Date: 08/23/17  
To: MQ Power Generator Owners  
From: MQ Power Product Department  
Subject: DEF Tank Cover Plate Replacement — **Mandatory Update**

**DCA150SSJU4F, DCA220SSJU4F and DCA300SSJU4F Generators  
DEF Cover Replacement**

<b>Product Group:</b> Power Solutions	<b>Date Issued:</b> 08/23/17	<b>Service Bulletin No.</b> GSP20170818
<b>Bulletin Type</b> <input checked="" type="checkbox"/> Mandatory <input type="checkbox"/> Information Only <input type="checkbox"/> Recommended Change		<b>Models/Series Affected:</b> DCA150SSJU4F S/N 7601131~7601140 DCA220SSJU4F S/N 8010878~8010997 DCA300SSJU4F S/N 9110041~9110075 AND S/N 9110086~9110095

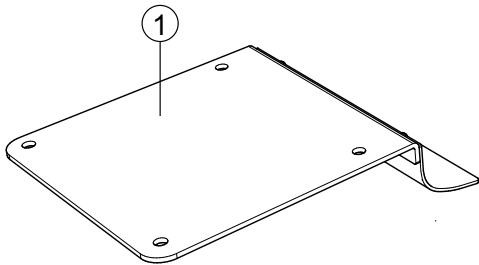
<b>Details</b>  <b>Problem:</b> Hot air flow from the radiator/intercooler blowing directly onto the Diesel Exhaust Fluid (DEF) tank can cause the fluid to become too hot. Temperatures at or above 150° F/ 65° C will cause the Engine Control Module (ECM) to generate a fault code and shutdown the engine.  <b>Solution:</b> Install new DEF tank cover plate that includes a rubber flap to <b>block/divert</b> incoming hot air from reaching the DEF fluid inside the tank.
---

**Figure 2. DEF Tank Cover Plate Installation**

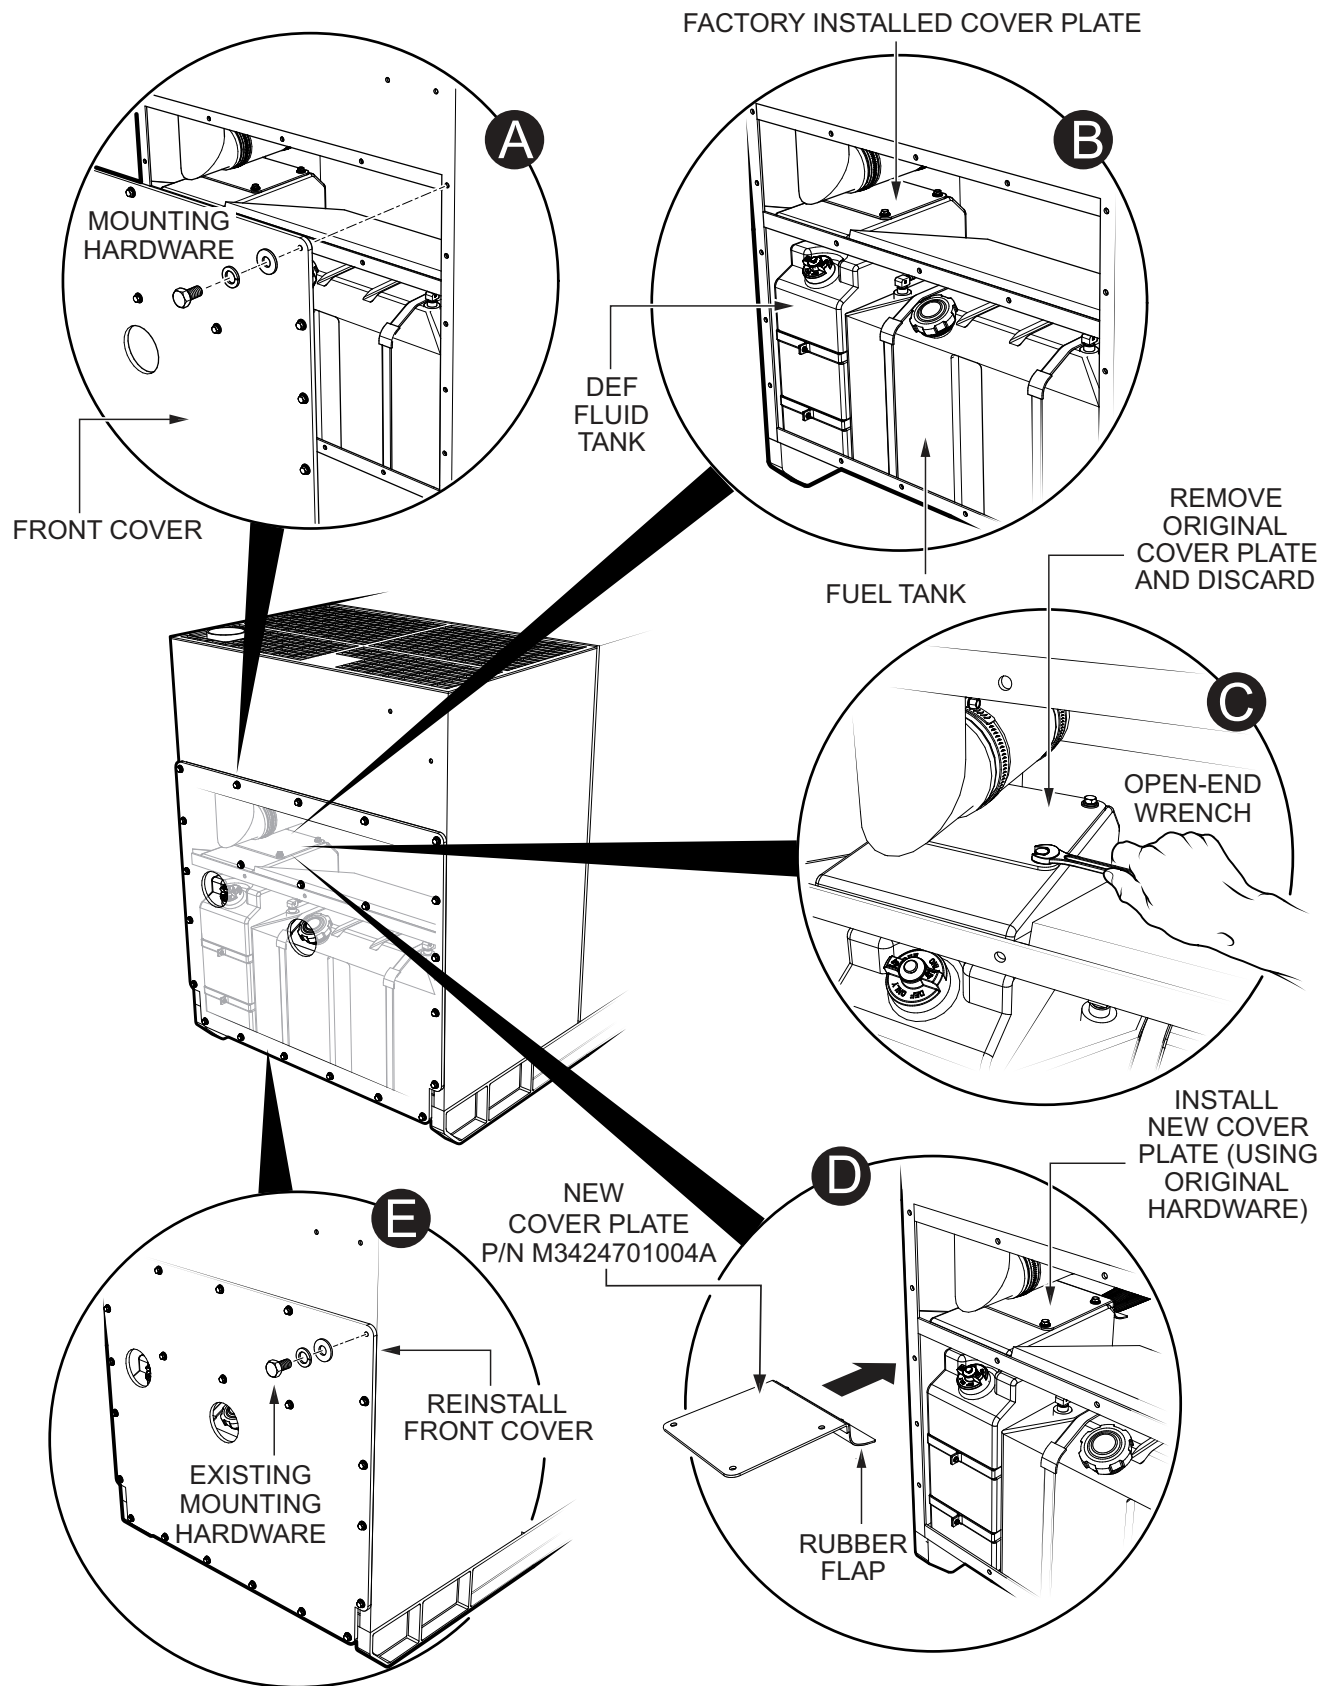
1. Using a 13mm socket or open-end wrench, remove the screws (Figure 2A) and associated hardware that secure the front panel to the frame.
2. Set front panel and mounting hardware aside.
3. If necessary remove any addition panels to gain access to the factory installed DEF tank cover plate (Figure 2B).
4. Using a 10mm open-end wrench, remove the **four** bolts from the factory installed cover plate as shown in Figure 2C. Retain mounting hardware.

5. Remove and **discard** factory installed cover plate. Retain mounting hardware.
6. Install new DEF tank cover plate P/N M3424701004A in same location (Figure 2D) as factory installed cover plate.
7. Secure new cover plate with mounting hardware that was removed in step 4.
8. Reinstall front panel (Figure 2E) and any other panels that were removed back onto the frame.
